**Canadian Estimate of Vehicle  
Mileage and Hydrogen Cylinder Cycles**

**Transport Canada**

**May 18, 2010**

Figure 1 Odometer readings recorded during emissions testing in 2009

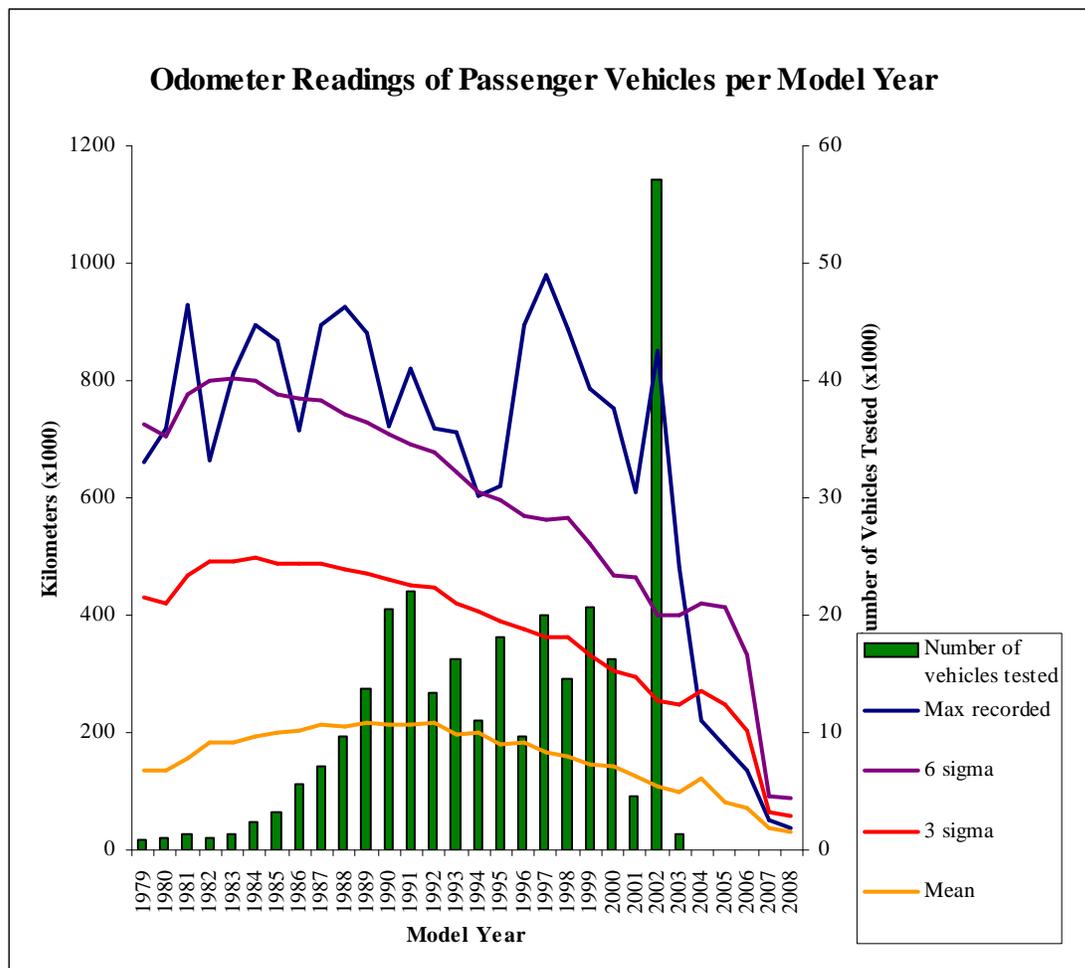
All models 13 years or older demonstrate 6 sigma values above 590,000 km. Contrary to the note in SGS-8-13re2 (A.5.1.1.5 e iv), for the majority of model years the maximum recorded odometer reading is well above the 6 sigma value. The highest recorded odometer reading is 981,000 km from a 12-year-old vehicle. [Note: Vehicles tested are still being driven and do not represent vehicles at the end of their life.]

Figure 2 Comparison of calculated extreme number of fuelings

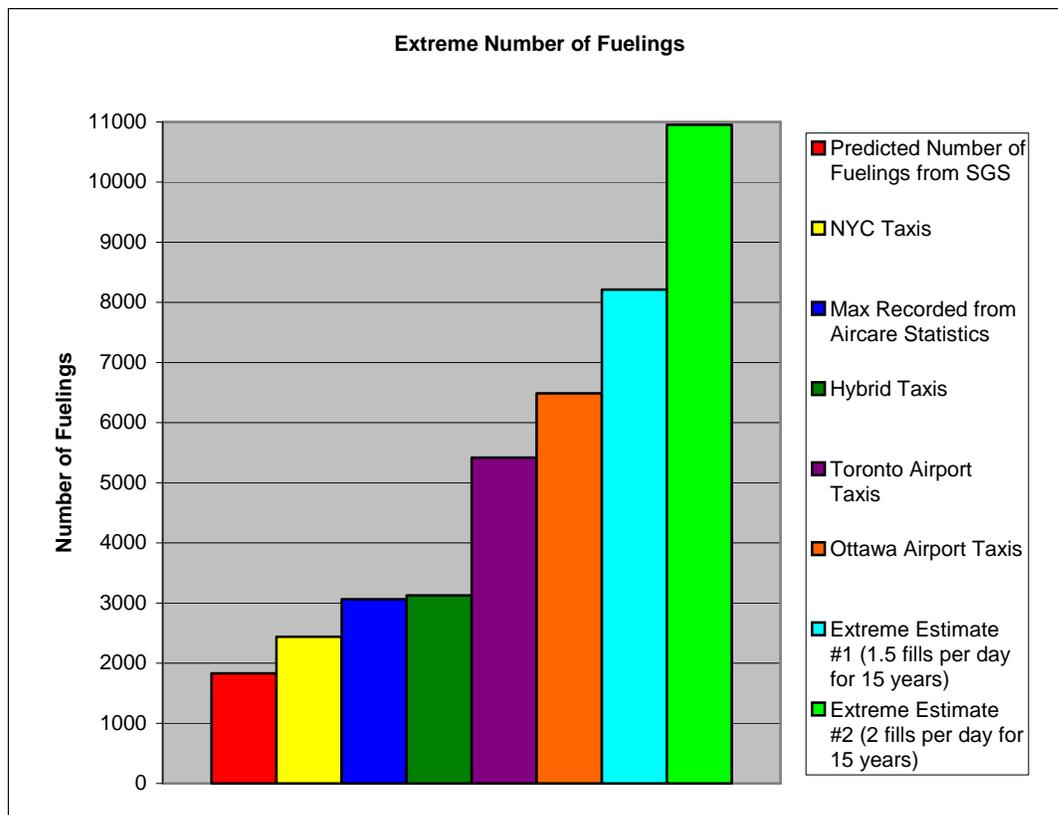
The extreme number of fuelings of 5500 is calculated in SGS-8-13r2e (A.5.1.1.5 e vi) using an extreme-usage lifetime vehicle range of 590,000 km, a minimal vehicle range per full fill of 320 km and a safety factor of 3. If this safety factor is removed, the number of fuelings predicted is 1833. In Figure 2, this value is compared with the number of fuelings calculated using mileage statistics from the sources presented in this paper (assuming the same minimal vehicle range per full fill of 320 km). Since the mileages are well above 590,000 km it is apparent that the corresponding number of fuelings is also above the predicted value.

As proposed, the cylinder itself will be certified for 15 years. There is a concern that in this time period a cylinder may be used in multiple vehicles. It is possible that a cylinder may outlast its original vehicle and could be transferred to another vehicle. It is also possible that a taxi operation may purchase or lease cylinders separate from the vehicle due to limited vehicle age requirements. An example of this took place in Canada with taxis fueled by natural gas. The cylinders were owned by a local utility and leased for a monthly fee to the operators. In such cases, high pressure hydrogen cylinders may be exposed to peak usage over their entire 15 year lifetime. Using the estimate of 1.5 fills per day from the Ottawa Airport, over 8000 fills would be possible and assuming an absolute worst-case of 2 fills per day, almost 11,000 fills would be achievable. Figure 2 demonstrates that these two extreme estimates exceed the predicted extreme number of fuelings by SGS-8-13r2e.

Based on mileage statistics it is apparent that the reduced 5500 cycle test, as was recently proposed in SGS-8-13r2e, is insufficient. The fact that cylinders may not be limited to one vehicle during the 15-year lifespan also raises concern with the proposed number of cycles. To maintain an adequate margin of safety for high mileage vehicles and for the possibility of cylinders being used in multiple vehicles, Canada recommends that the 11,250-cycle life, as previously proposed for commercial vehicles, be applied to all vehicles.
